February 13, 2006

NAME OF PROJECT: Havenwood at Hunter's Crossing; Located on the northwest side of FM 1102, approximately 1.3 miles north of the intersection of FM 1102 and Hoffman Lane; Comal County, Texas

TYPE OF PLAN: Request for Approval of a Water Pollution Abatement Plan (WPAP); 30 Texas Administrative Code (TAC) Chapter 213 Edwards Aquifer; Edwards Aquifer Protection Program ID No. 2408.00, Investigation No. 432792, Regulated Entity No. 432792

WPAP Figure Detail

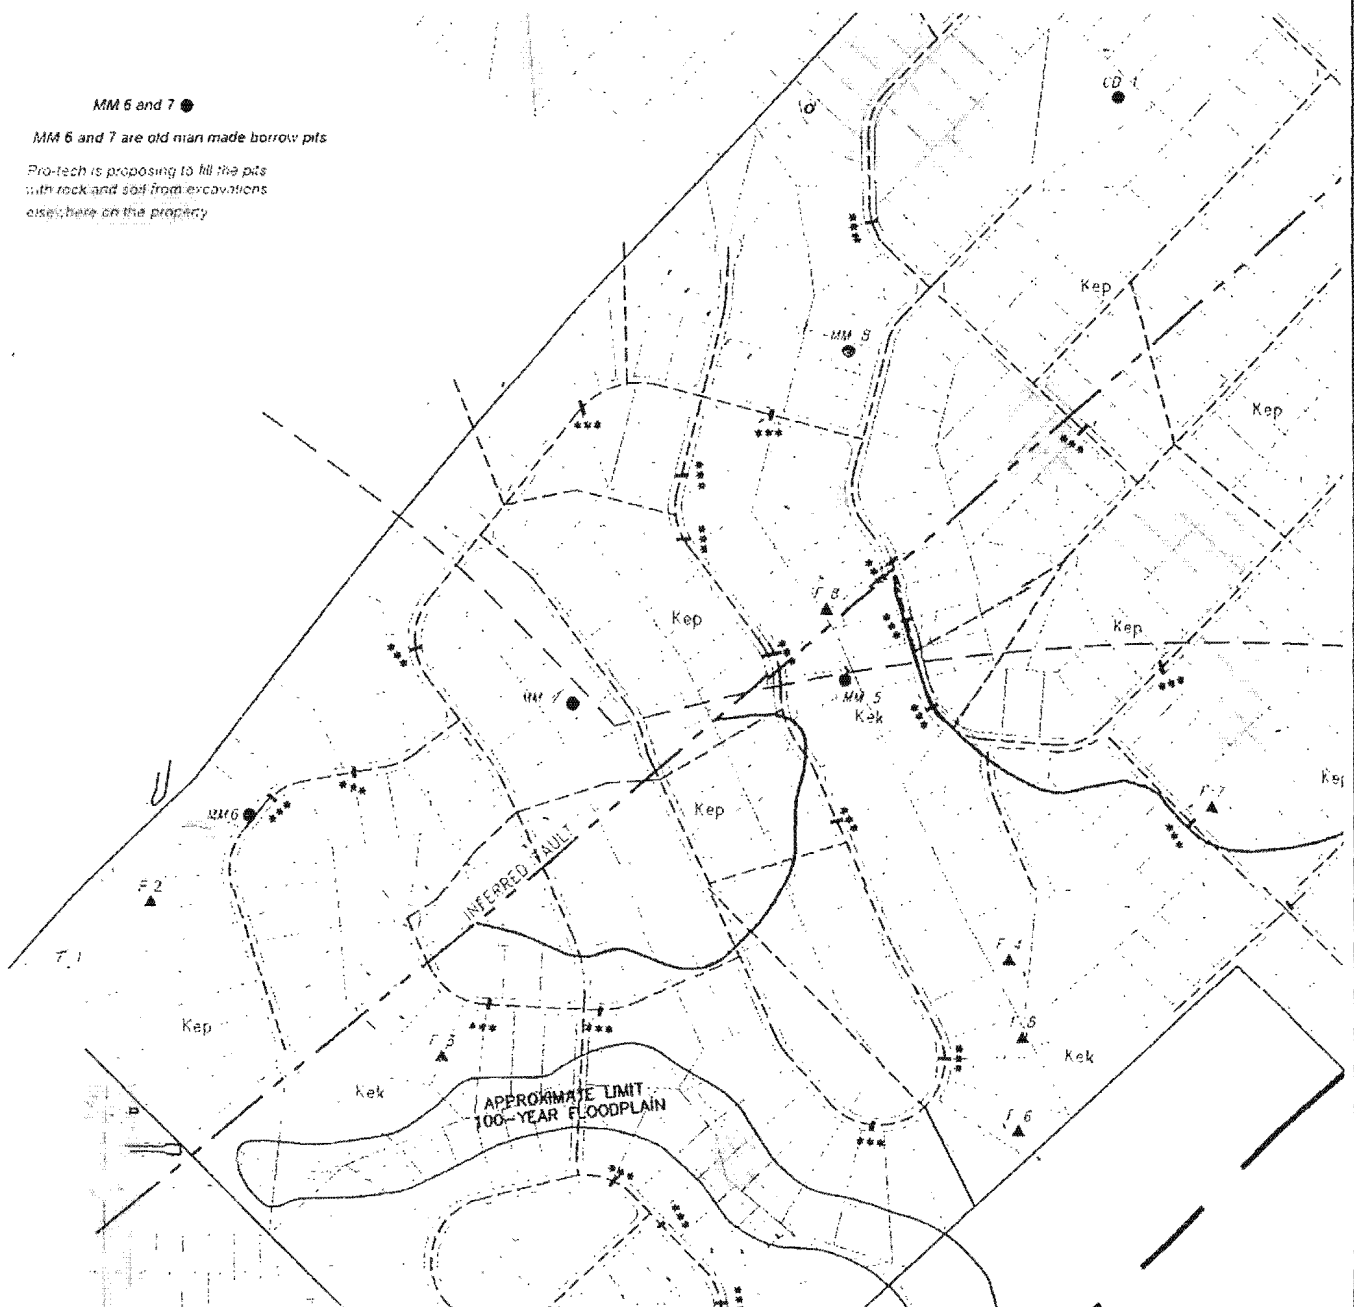
Attached is a figure showing the location of the borrow pits on the property. Pro-Tech proposes to fill the pits with soil and rock excavated from elsewhere on the property.

Identify the borrow pits on the site plan, and describe what material you will be filling them with. Send it in and we'll look at it.

The Texas Commission on Environmental Quality has no objection to filling the borrow pits with clean soil and rock excavated from the site. If you have any questions or require additional information, please contact John Mauser of the Edwards Aquifer Protection Program of the San Antonio Regional Office at (210) 403-4024.

MM 6 and 7 are old man made borrow pits

Pro-tech is proposing to fill the pits with rock and soil from excavations elsewhere on the property.

Photo 1. View of the closed depression. The center of the depression is a muddy area heavily used by cattle after a rain.

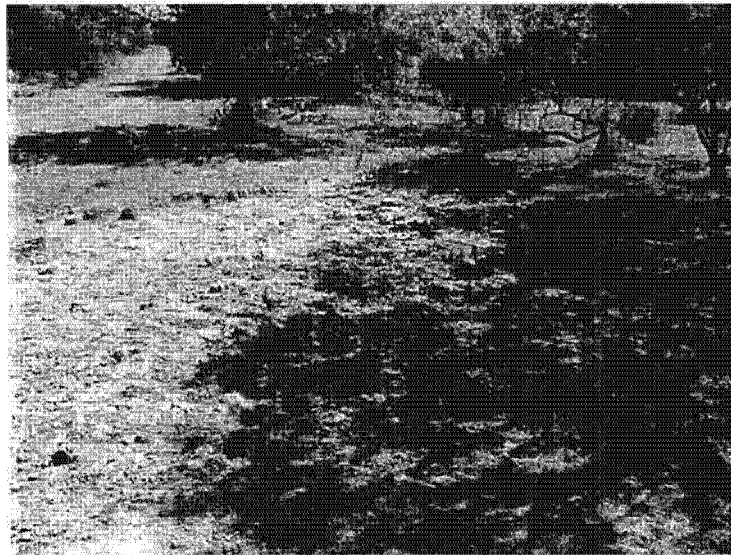
3. Site plan: 1) add scale on site plan (Geologic Map must be at the same scale as the site plan), and 2) label contour lines.
4. Describe the topographic anomaly located approximately 1,100' NNW of feature MM-8, and provide an assessment by the project geologist, if necessary.

Geologic Feature CD2: This is a second feature apparent in the topographic contours after completion of the mapping. The feature is a closed depression about 100 feet by 100 feet by about 10 feet deep in the deepest part, which is the middle. It is a circular, shallow bowl-shaped feature. In the center of the depression is a small muddy area that is heavily used by cattle. The feature is filled with dried mud. The filling of the center of the depression with dried mud indicates downward migration is limited and water ponds in the depression following rain. It apparently catches perched water after a rainstorm as indicated by the heavy use by cattle when still wet. Photographs of the depression are shown below.

ROCK BERM

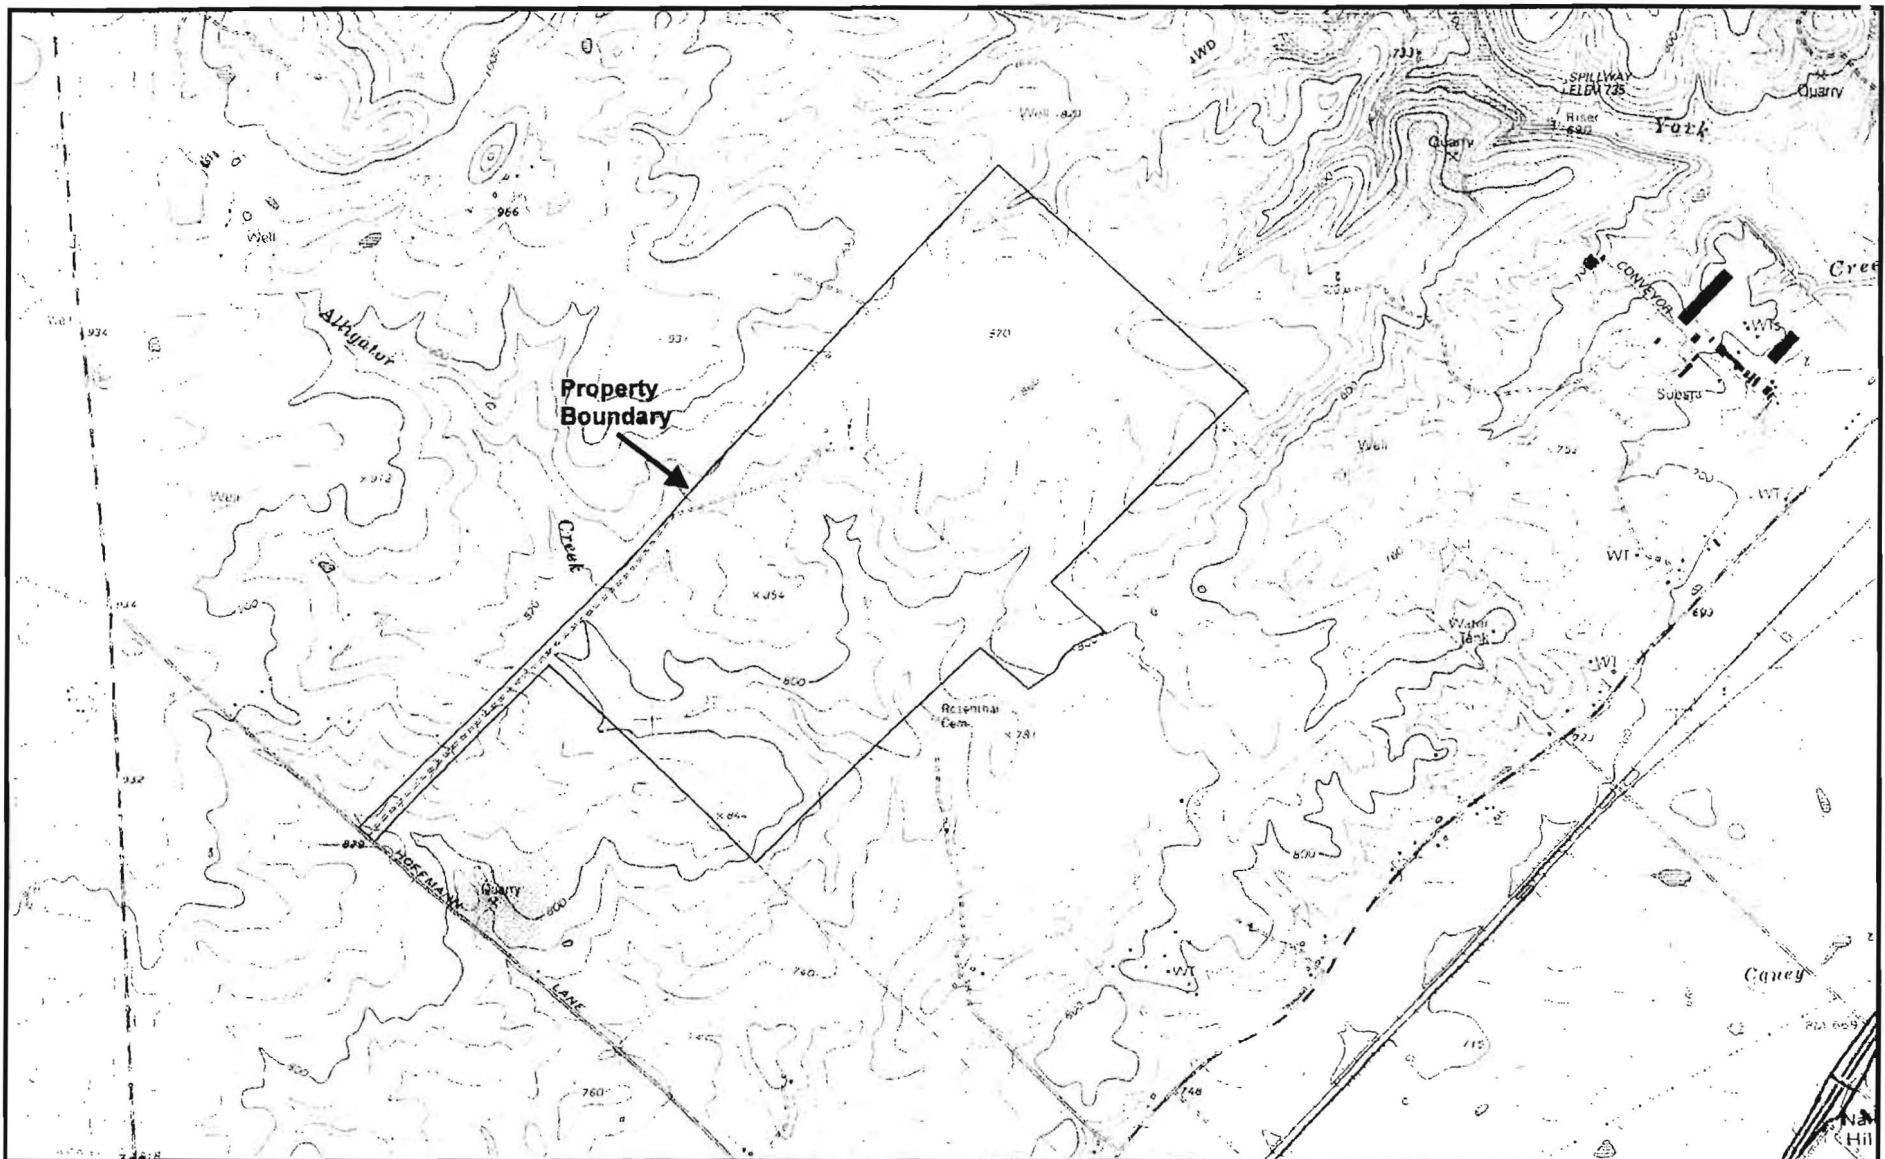
5. Show detail of wire sheathing on rock berm, as described in the Inspection & Maintenance Guidelines for Rock Berms.
6. PG seal on Geologic Assessment Tables, and Geologic Map (seal & signature)
